EFFECT OF BUS_SET_DELAY ON MAXIMUM DOMAIN DELAY

T10/97-223r0

Motion to change bus_set_delay in SPI-2

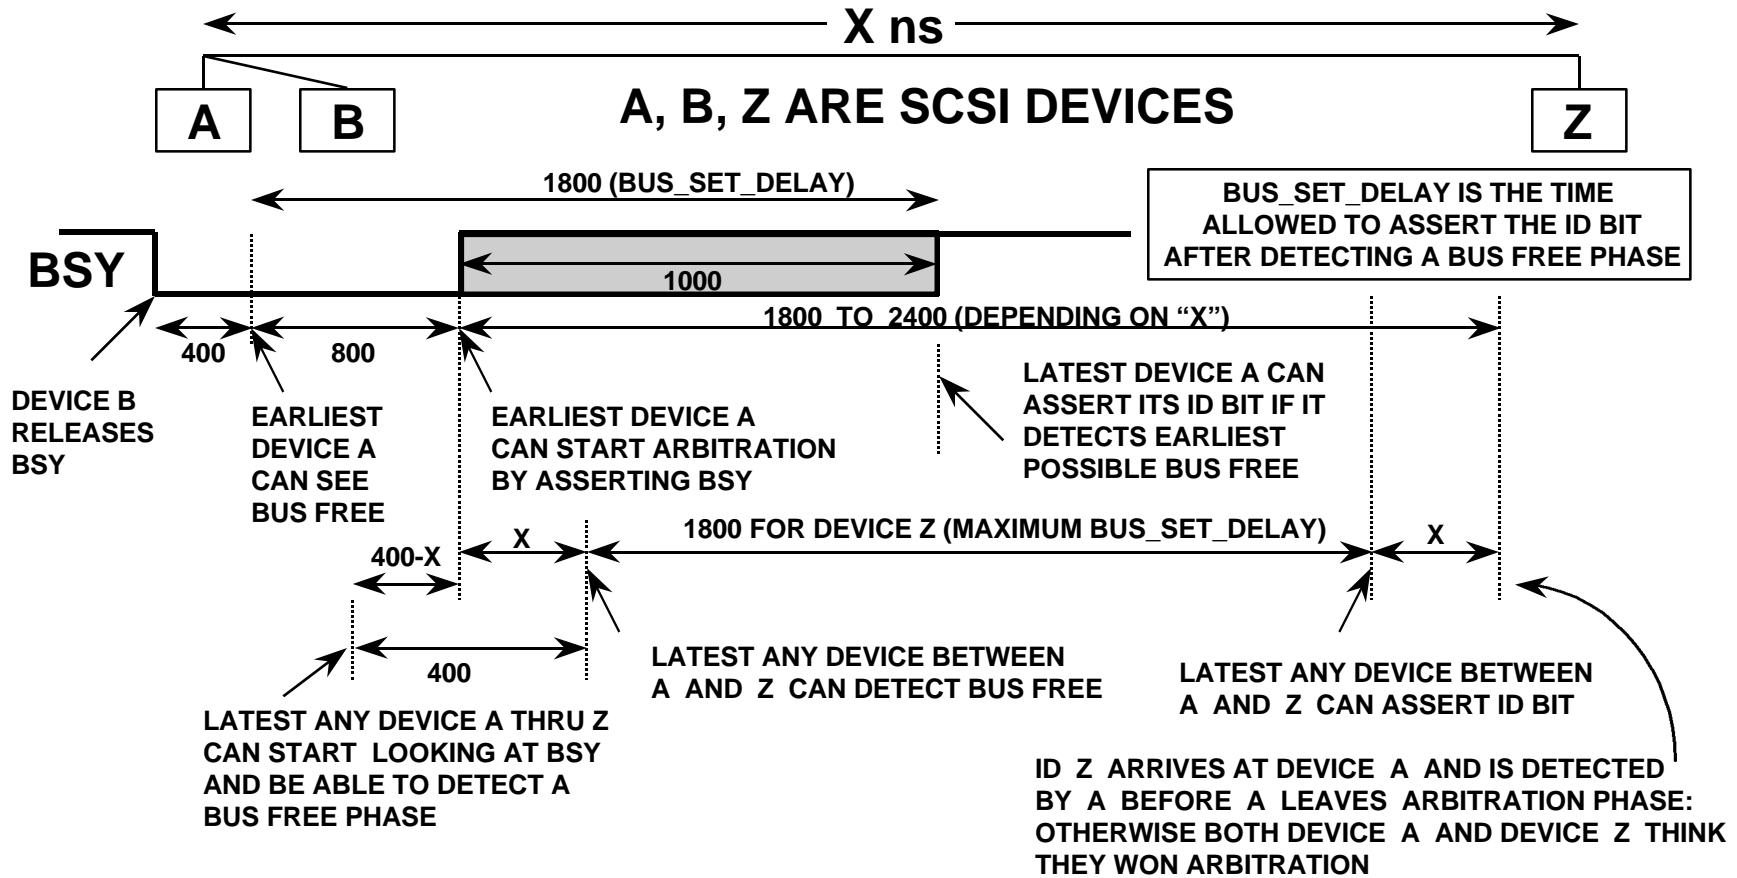
WORST CASE UNDER ABOVE ASSUMPTIONS: $2X + 1800 = 2400 \Rightarrow X = 300$ ns

NEED TO REDUCE MAXIMUM BUS_SET_DELAY TO 1600 ns OR LESS IN ORDER TO RECOVER THE FULL 400 ns PROPAGATION TIME ALLOWED BY THE BUS SETTLE DELAY

THIS SHOULD NOT BE A PROBLEM FOR ANY MODERN DEVICES THAT USE KNOWN CLOCK RATES AS THEIR RESPONSE TO BUS FREE AND DESIRE TO ARBITRATE WILL BE VERY FAST

- **Motion: that SPI-2 require 1600ns maximum for bus_set_delay**
- **Note: this is a 200 ns reduction from the present 1800ns that does not affect any recently designed devices (per working group discussions) [these devices actually do not need anywhere near the full 1800ns but only the 200ns reduction needed is requested to minimize impact on much older devices in large domains]**
- **Note: this change allows the maximum worst case domain delay to be the bus_settle_delay limit of 400 ns -- with the present 1800ns for bus_set_delay (and devices that use the entire 1800ns) the domain delay is reduced to 300ns**
